**Mack Trucks, Inc.**

# **Service ALERT**

**Date:** 04 May 2005 **Number:** SA-231-002  
**To:** All U.S. & Canadian Distributors  
**Attention:** Service Manager, Warranty Manager, Parts Manager  
**From:** Mack Reliability Engineering Department  
**Subject:** Re-Activation for SC-292 Safety Campaign

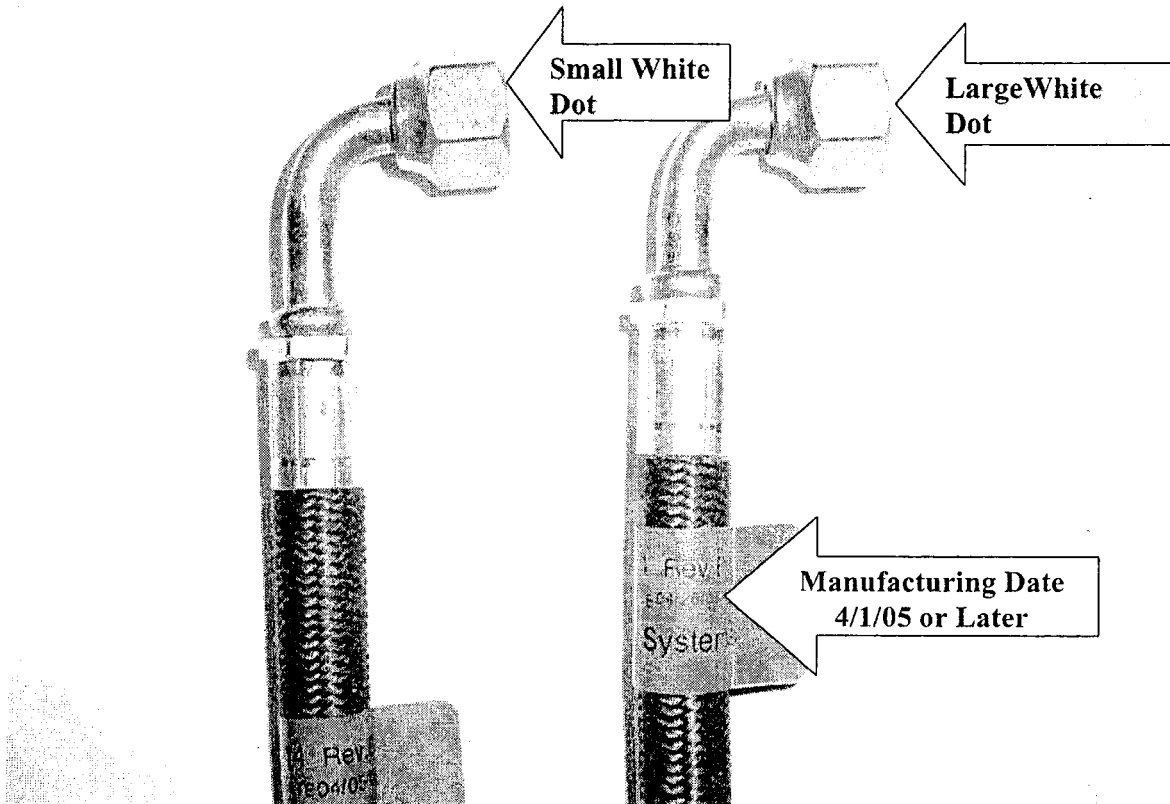
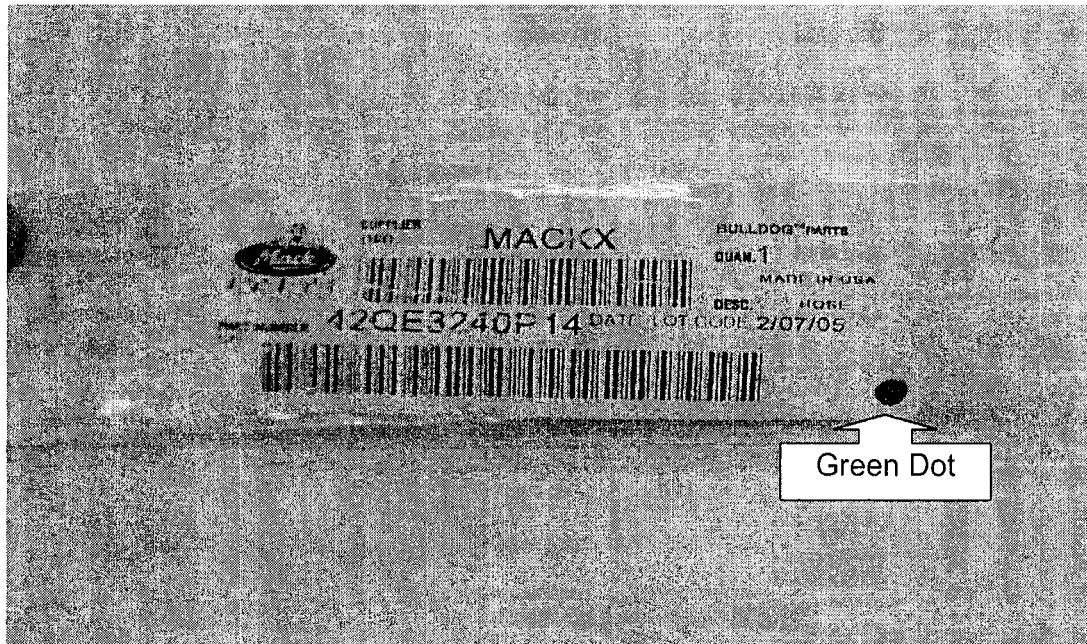
All dealer inventory of the 42QE3240P14 hoses **with and without the green dot must** be returned per the recall instructions that were sent out on April 18, 2005 and April 21, 2005 by the Mack Service Parts Organization. **Disregard the blue dot on the fitting of the fuel hose.**

Use only a 42QE3240P14 fuel supply hose with a **manufacturing date of 4/1/05** or later for this campaign. The manufacturing date is located on an orange tag attached to the hose. All of these hoses will be marked with a **small or large white dot** on the hex nut. See illustration above for date and dot locations.
